DEEPSEA YANTAI

DROPS INSPECTION PICTURE LOG

August 2023 | AXESS PROJECT NO 258034-16 | PO: TBA

Subject: Deepsea Yantai DROPS Inspection Picture log 2023			
Client: Odfjell Drilling		Installation: DeepSea Yantai	
Client contact onshore: Kenneth Andersen		Client contact offshore: Chief Engineer	Axess project manager: Elin Gjerde
Axess project no.: 258034-16		Client PO no.: TBA	Document no.: 258034-16-278-01
Revision: 02	Changes: Final report	Written by: Kjetil Ask	Approved by: Elin Gjerde
		28.09.2023	10.10.2023
Revision: 01	Changes: Preliminary report (MOB 2)	Written by: Kjetil Ask	Approved by:
		28.09.2023	
Revision: 00	Changes: Preliminary report (MOB1)	Written by: Roger Eidem	Approved by:
		21.08.2023

Finding: 1.1

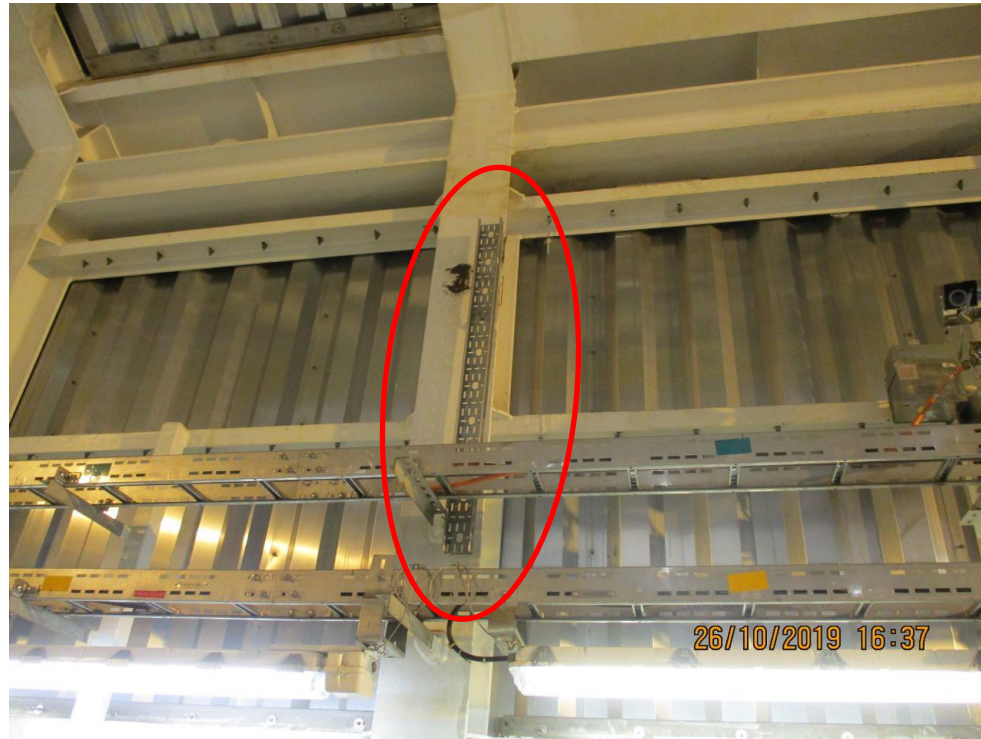
Redundant cable tray.

Remove, if not required.

Finding: 1.3

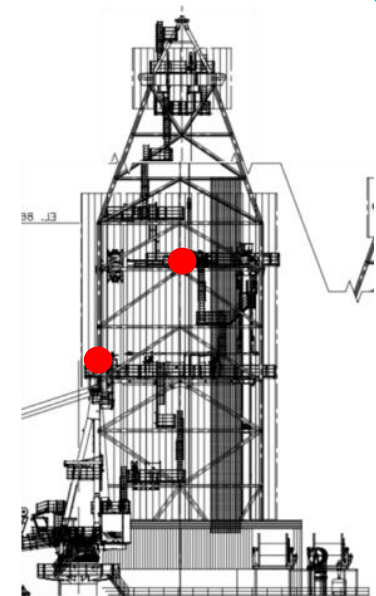
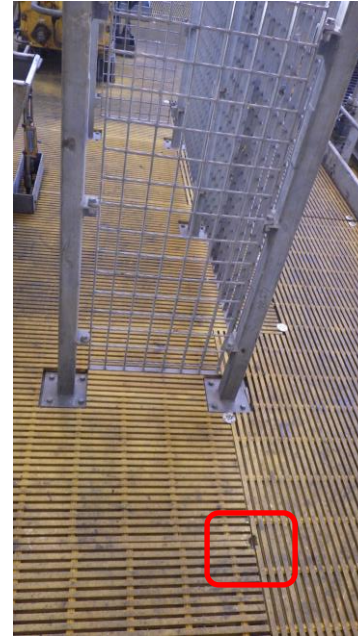
Missing grating clips.

Install missing grating clips

Finding: 1.6

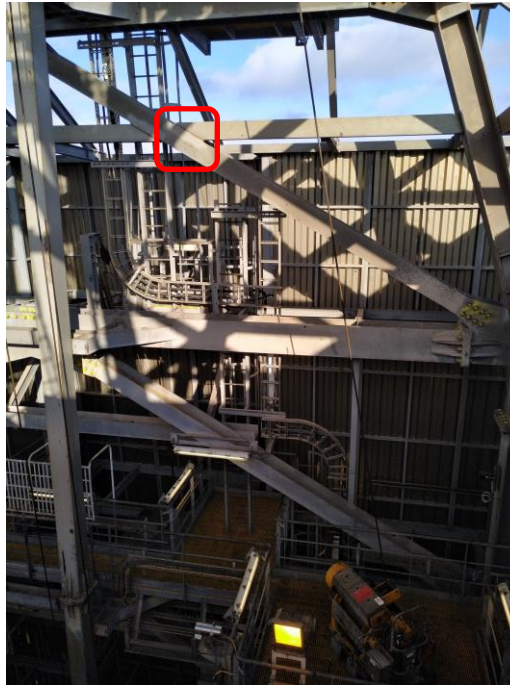
Gap between bolted connection on structure.

Shims between connection should be used

Finding: 1.11

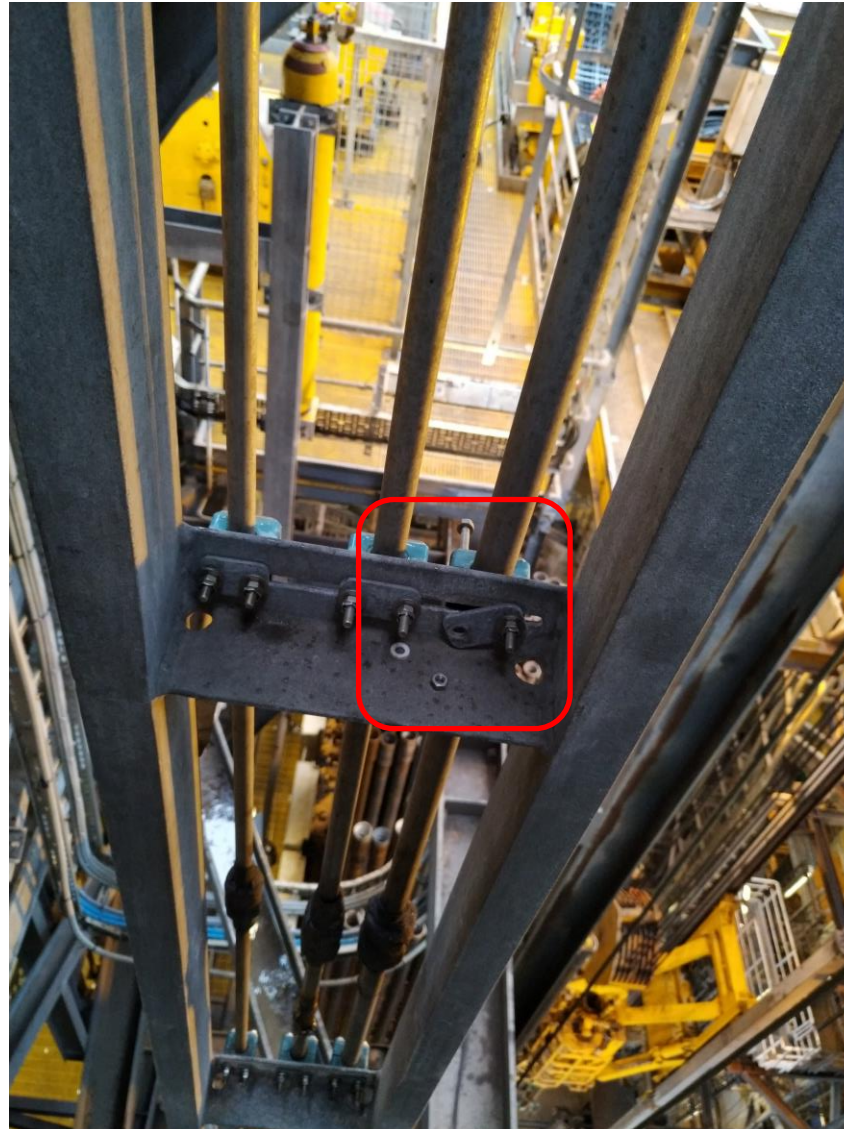
Description:
Loose bolts on pipe brackets

Loose bolts have been removed.

Install new bolt.

Finding: 1.13

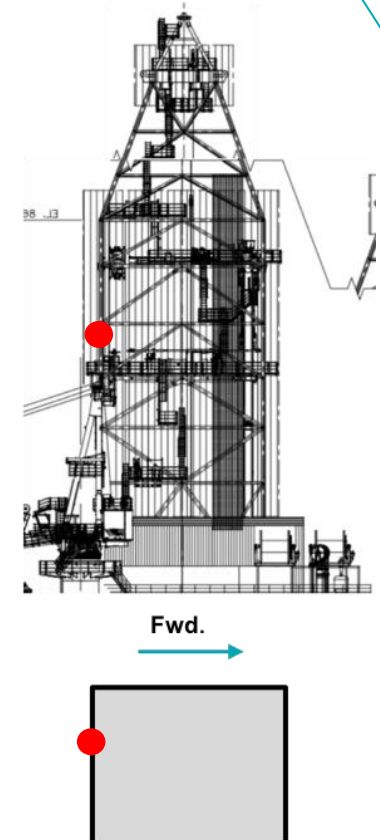
Equipment left at height.

Remove equipment.

Finding: 1.14

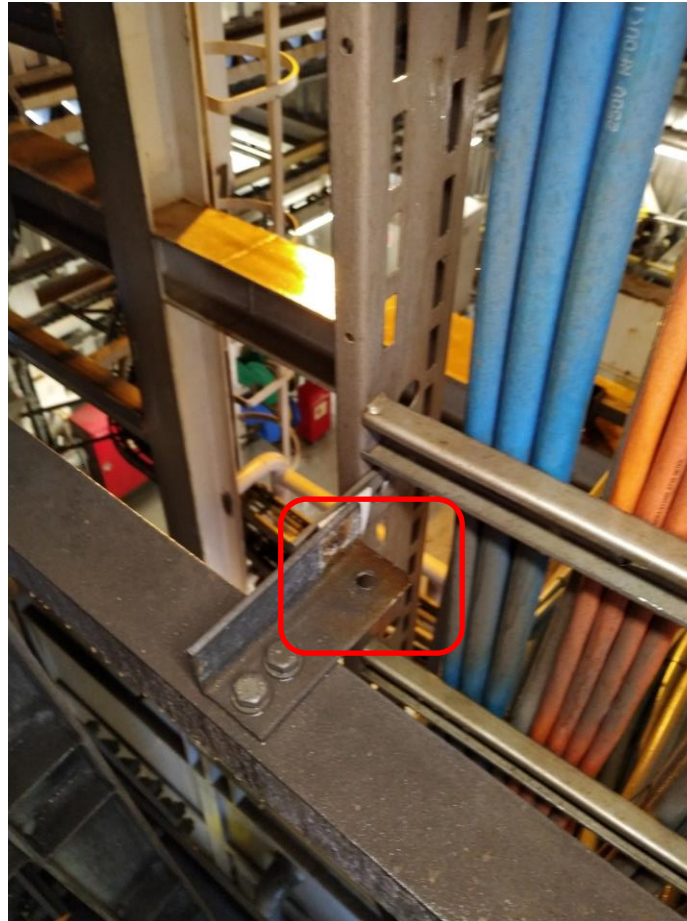
Missing bolt on support to cable tray

Install new bolt

Finding: 2.2

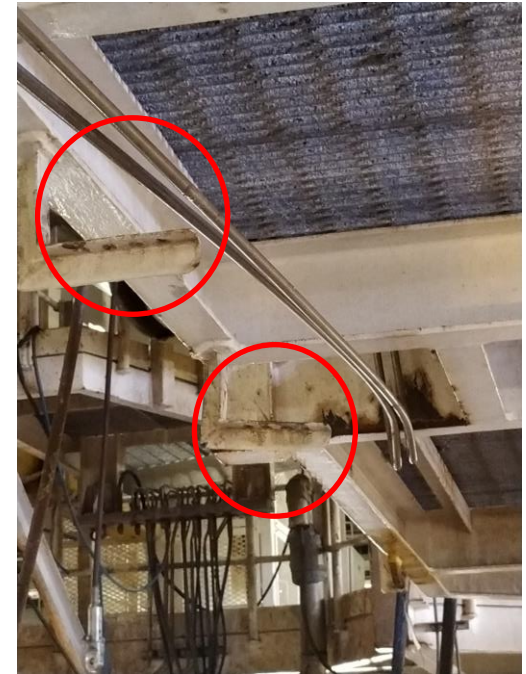
Description: Missing brackets on pipe

Required action:
Install clamps on pipes

Finding: 2.3

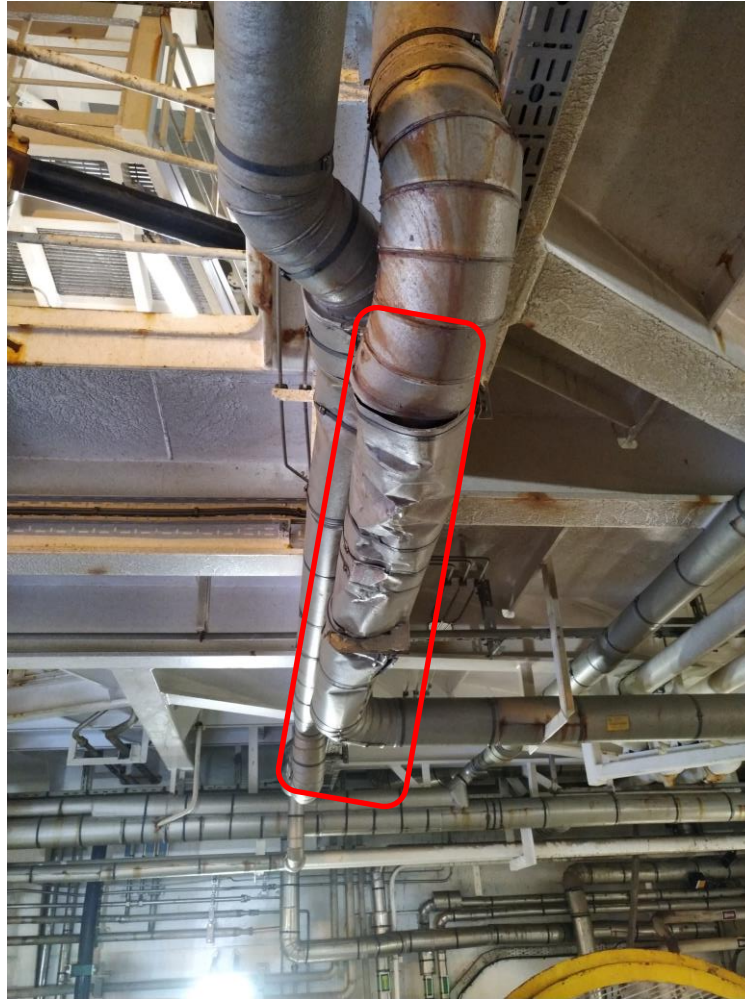
Description: Insulation cladding damaged.

Required action:
Recommend to change.

Finding: 2.4

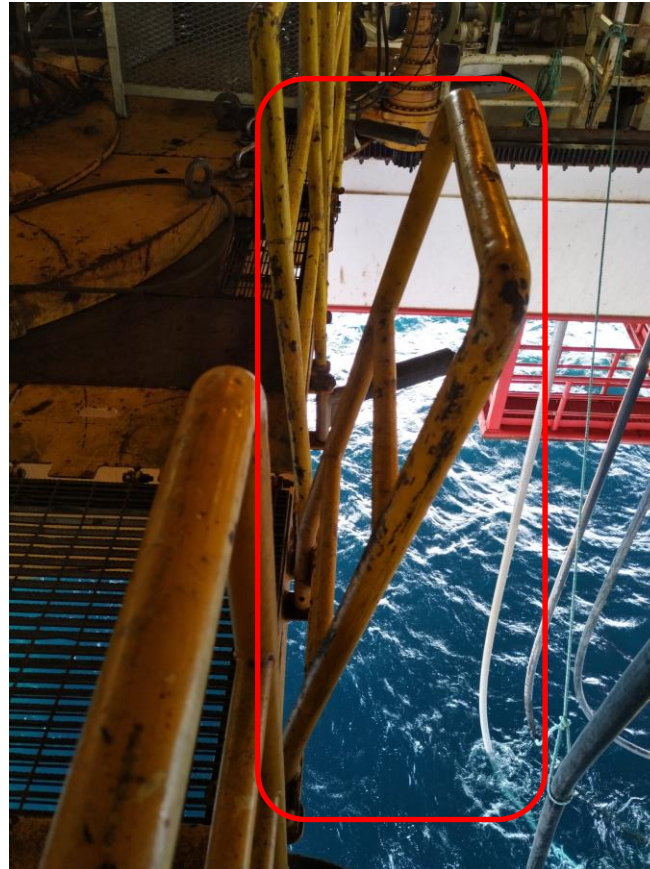
Description: Movable railings its damaged and not secured with safety bolt in bracket.

Required action:
Change out damaged railing and secure with bolt.

Finding: 2.7

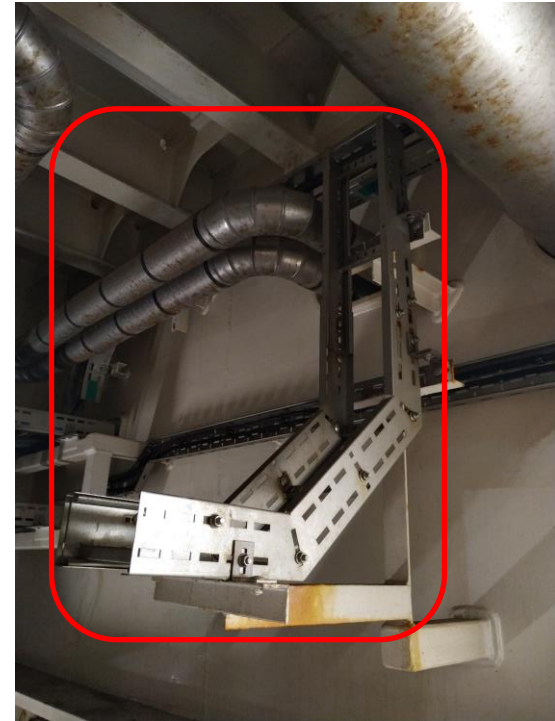
Redundant cable tray.

If not to be used, we recommend to remove all unnecessary equipment in height.

Finding: 2.8

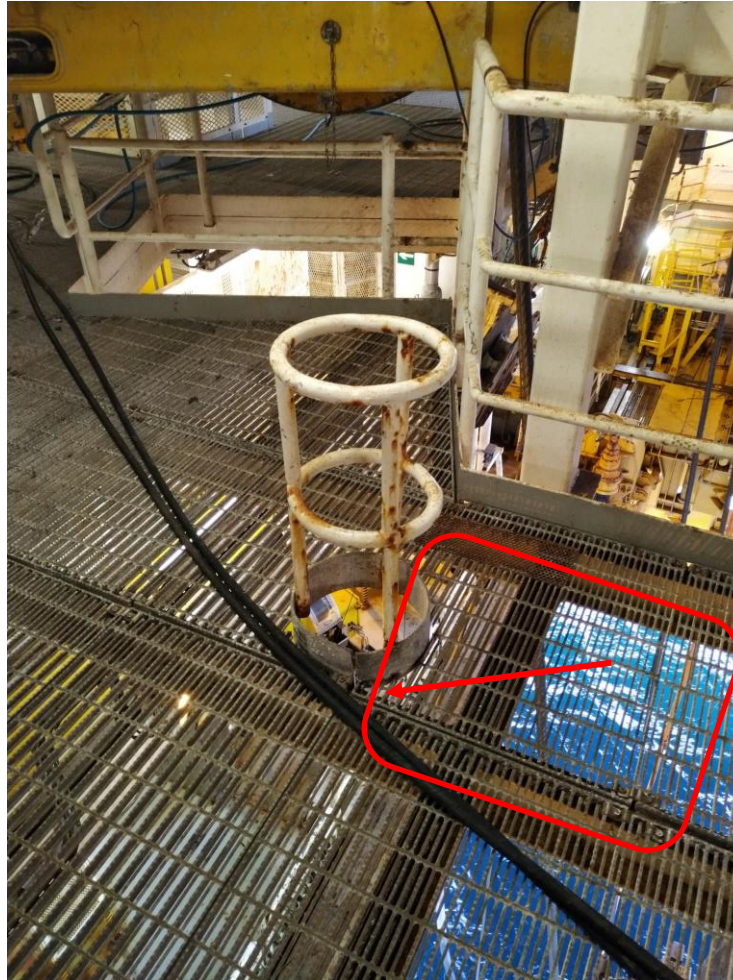
Missing grating clips.

Install missing grating clips

Finding: 2.9

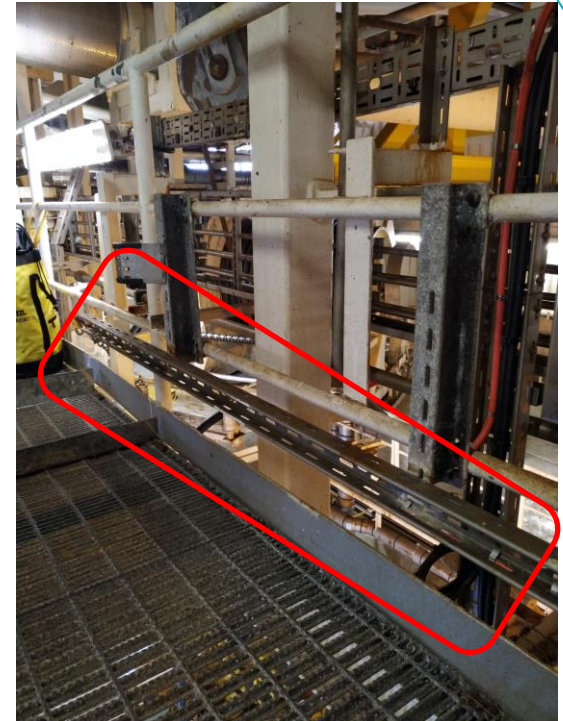
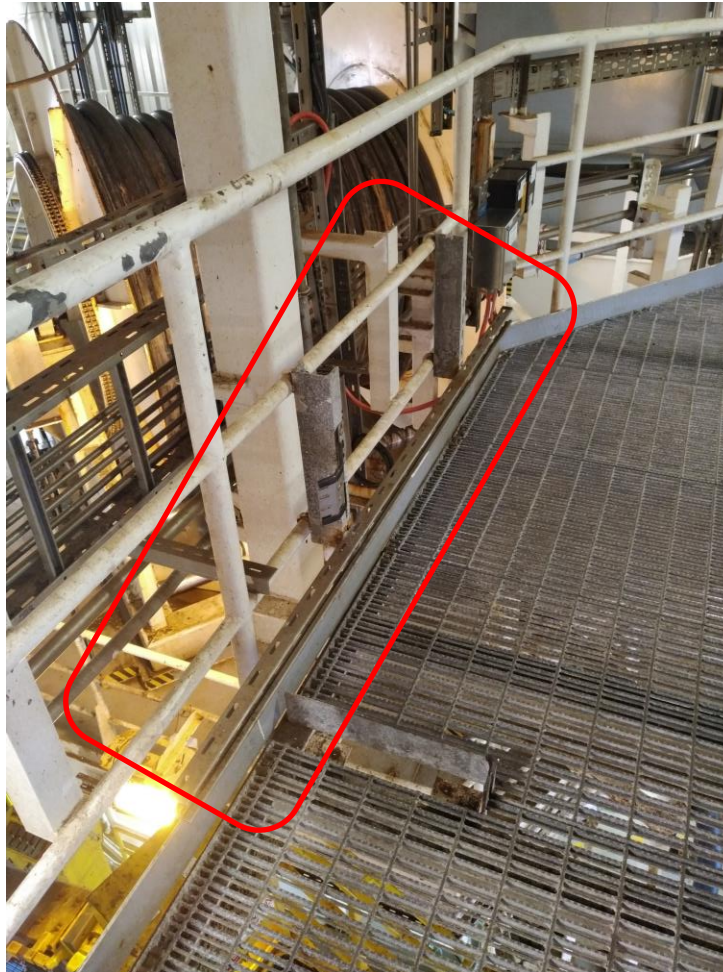
Redundant cable tray.

If not to be used, we recommend to remove all unnecessary equipment in height.

Finding: 2.10

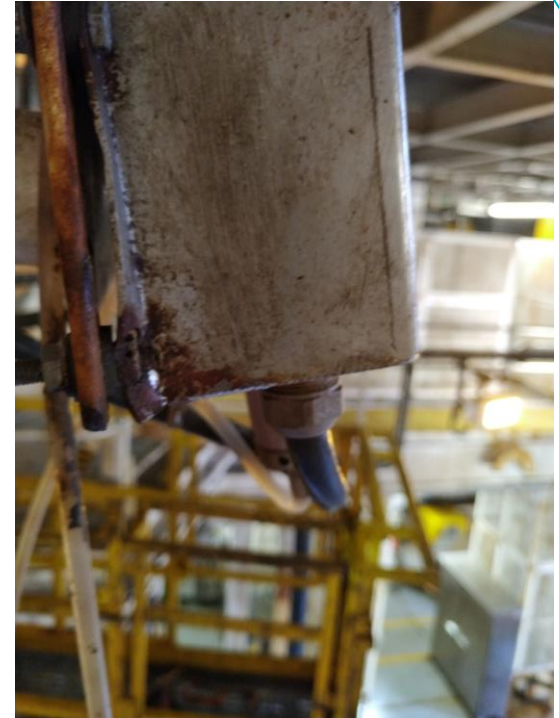
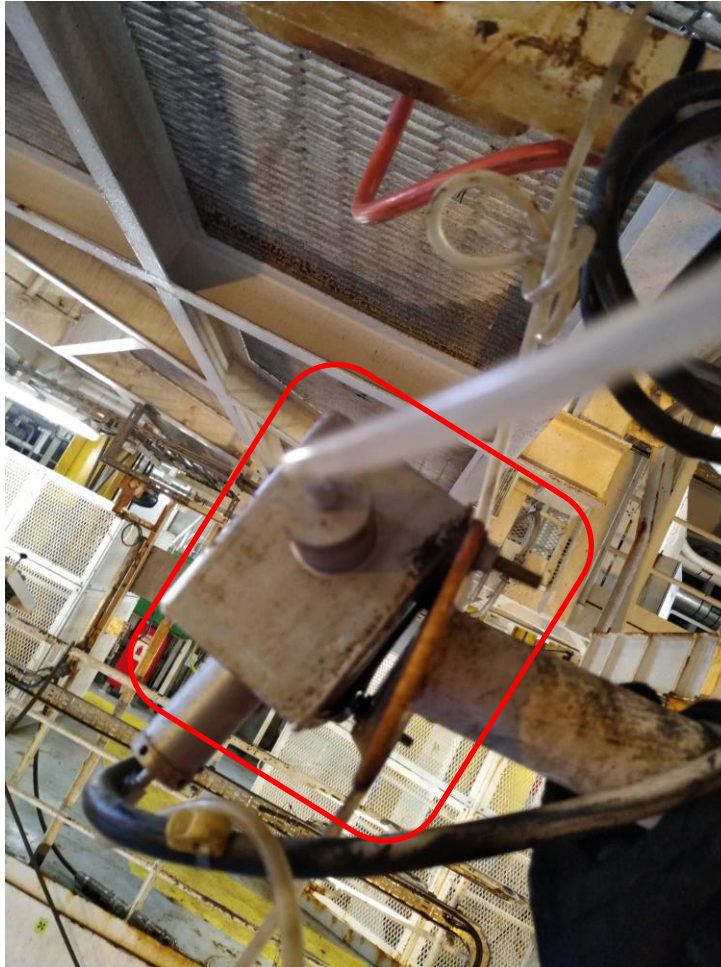
Missing bolt on washer fluid tank.

Install missing bolt.

Finding: 2.11

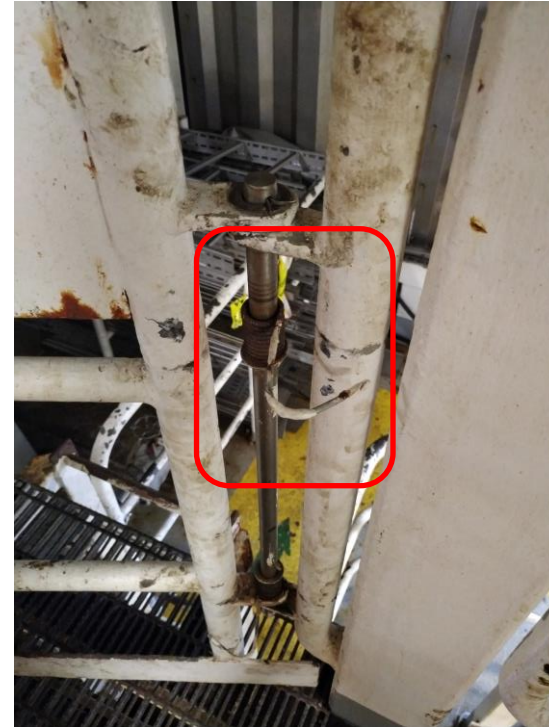
3 gates is not self-closing. Spring is broken.

Install new springs.

Finding: 2.12

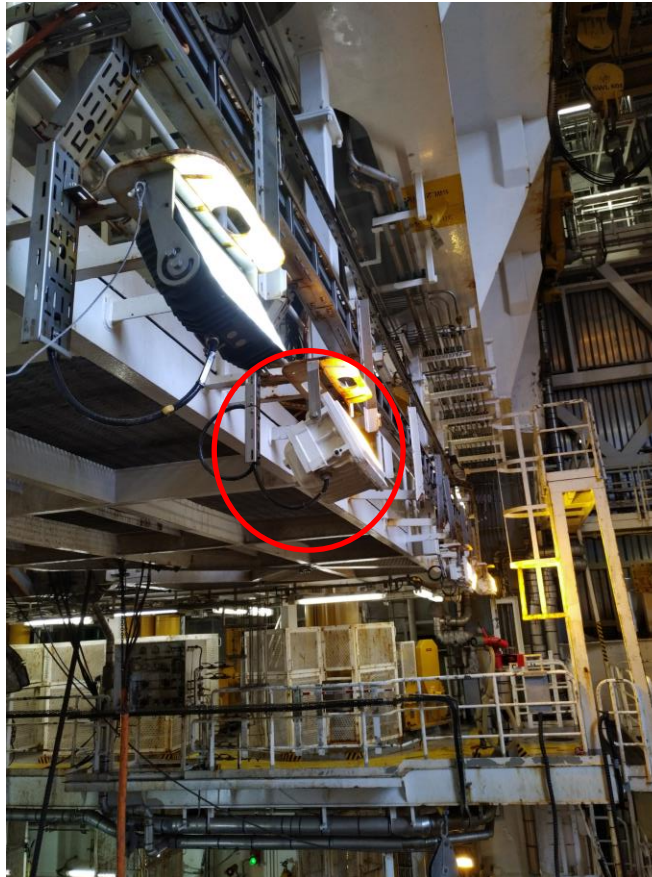
Description: Missing secondary retention

Required action:
Install secondary retention

Finding: 3.2

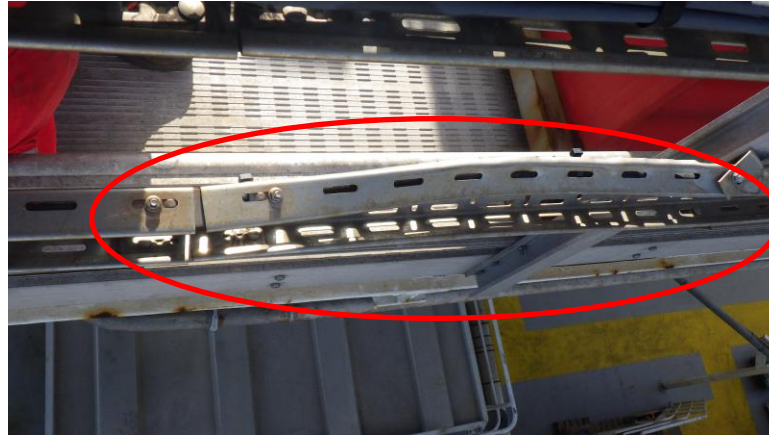
Description: Damaged cable tray

Required action: Replace cable tray

Finding: 3.6

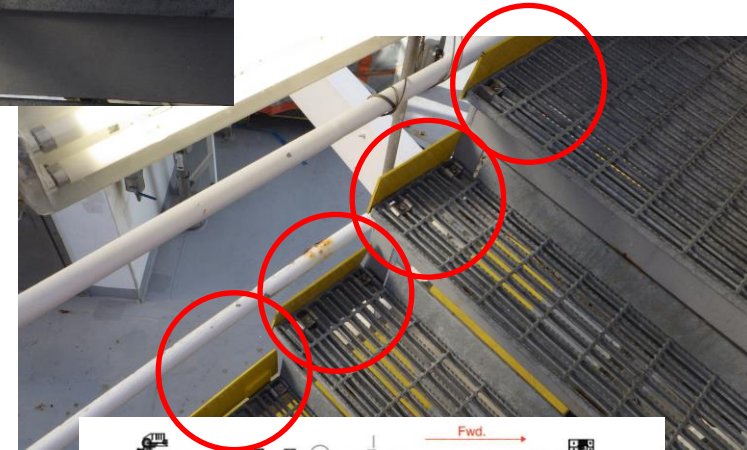
Description: Loose skirting on the staircase to the walkway to the bridge port and stb side

Required action: Replace bolts on skirtings

Finding: 3.7

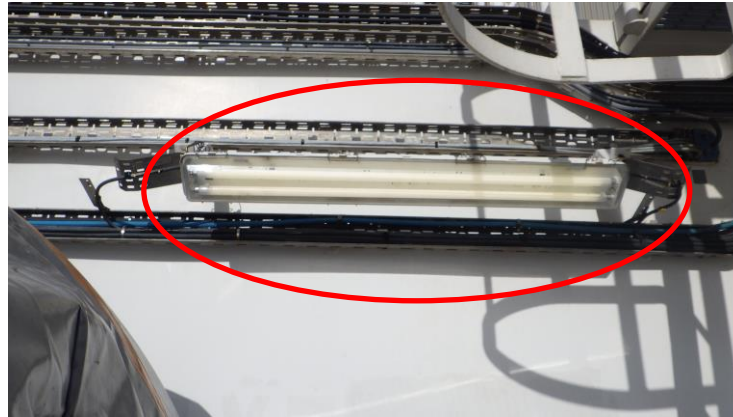
Description: Loose skirting on the staircase to the walkway to the bridge port and starboard side

Required action: Replace bolts on skirtings

Finding: 4.1

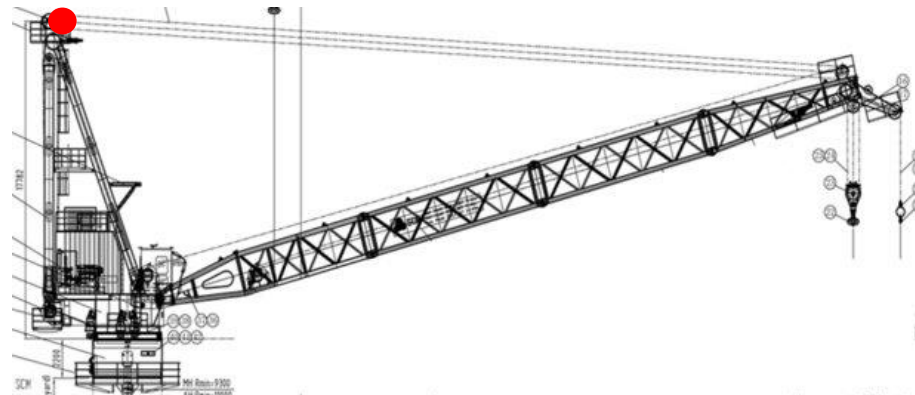
Description: Wind sensor with moving parts should be replaced with an ultrasonic sensor

Required action: Replace with ultrasonic sensor
